# Technical Service Bulletin

## 94 Xenon headlights are adjusted too low

94 13 09 2032852/2 February 26, 2013. Supersedes Technical Service Bulletin Group 94 number 13-08 dated February 26, 2013 for reasons listed below.

Model(s)	Year	VIN Range	Vehicle-Specific Equipment
A4	2013	000001-999999	Xenon headlights

**Figure 2.** New MY2013 A4 xenon headlight beam pattern

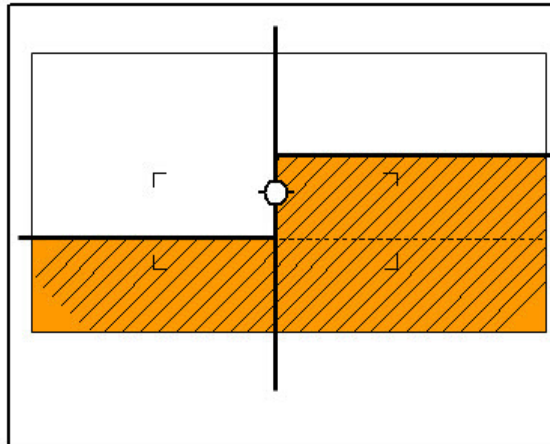
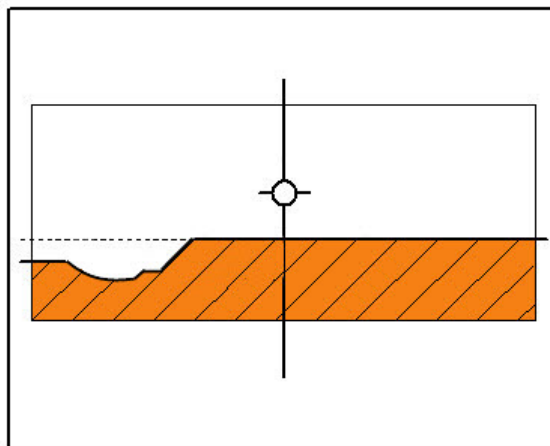
**Distinct cut-off beam pattern:** The light distribution of the MY09-MY12 headlight has a very sharp cut-off beam pattern (Figure 1). This is most noticeable when driving through long dips in the road (i.e., when coming to the bottom of a large hill).

**Modified light distribution for MY2013 A4:** The illumination of the headlight has been changed for the MY13+ A4 to help further reduce the amount of light seen by oncoming traffic (Figure 2).

**Figure 3.** Comparison of new and previous generation headlight beam pattern

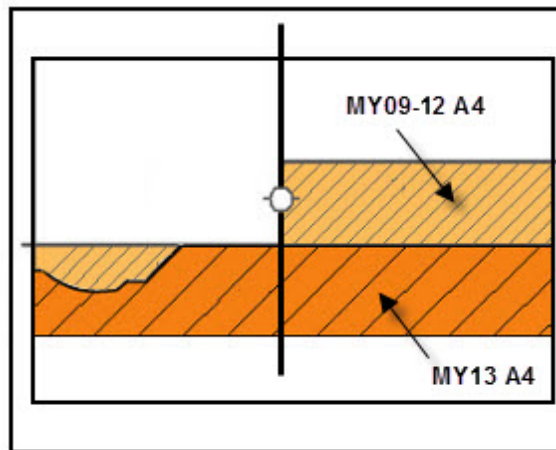
Explain to the customer the changes in the beam for current MY2013 A4 vehicles (Figure 3). Explain the risks of adjusting the beam too high, which may cause an unsafe condition for oncoming traffic.
